Access Compliance Report Public Rights-of-Way (Curb Ramps)

Intersection ID: 14212 Main Street: HAWKINS_ST Cross Street: W_TREMONT_AV Location: SW

ADA ID: 721D4C28987C Ramp Type: PerpDiag Initial Pass/Fail: Fail Overall Compliance: No Severity Score: 26.25

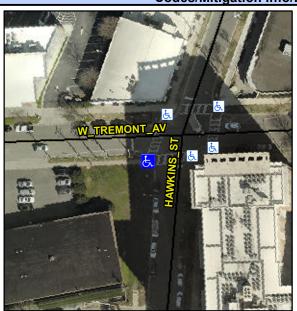
Not Found, R304.2.2, R304.5.3

Field Measurements/Component Compliance					
Compliance Description		Data	Comp	liance Description	Data
N/A	Ramp Length (in)	51.0	No	Ramp Slope (%)	12.9
Yes	Ramp Width (in)	48.0	No	Ramp XSlope (%)	4.9
N/A	Flare Type LT	N/A	N/A	Flare Type RT	N/A
N/A	Flare Slope LT (%)	N/A	N/A	Flare Slope RT (%)	N/A
N/A	Flare Traversable LT?	N/A	N/A	Flare Traversable RT?	N/A
N/A	Landing Length (in)	N/A	N/A	DWS Provided?	N/A
N/A	Landing Width (in)	N/A	N/A	DWS Contrast?	N/A
N/A	Landing Slope (%)	N/A	N/A	DWS Length (in)	N/A
N/A	Landing X Slope (%)	N/A	N/A	DWS Full Width?	N/A
N/A	Landing Curb? (Y/N)	N/A	N/A	DWS Offset (in)	N/A
N/A	Shared Landing?	N/A			
N/A	Gutter Ponding?	N/A	N/A	Gutter Slope (%)	N/A
N/A	Gutter Lip Ht (in)	N/A	N/A	Gutter X Slope (%)	N/A
N/A	Painted X Walk1?	No	N/A	Painted X Walk2?	Yes
	X Walk 1 Direction	То Е		X Walk 2 Direction	To NE
N/A	X Walk 1 Width (in)	N/A	N/A	X Walk 2 Width (in)	96.0
	X Walk 1 Slope (%)	2.6		X Walk 2 Slope (%)	0.7

X Walk 1 X Slope (%)	0.0		X Walk 2 X Slope (%)	5.2
N/A	Ramp inside XWalk1?	N/A	N/A	Ramp inside XWalk2?	Yes
	Road Slope (%)	5.2	N/A	Clear Space?	N/A
	Road X Slope (%)	9.1	N/A	Clear Space to XWalk (in)	N/A
N/A	Any Obstructions?	N/A	N/A	Storm Grate/Utility Hazard?	N/A
	Obstruction Type			Storm Grate/Utility Type	
		N/A			N/A
			Yes	Surface Condition? (G/P)	Good
	THE

Remove & Replace Curb Ramp With Two New Directional Ramps or Equivalent.
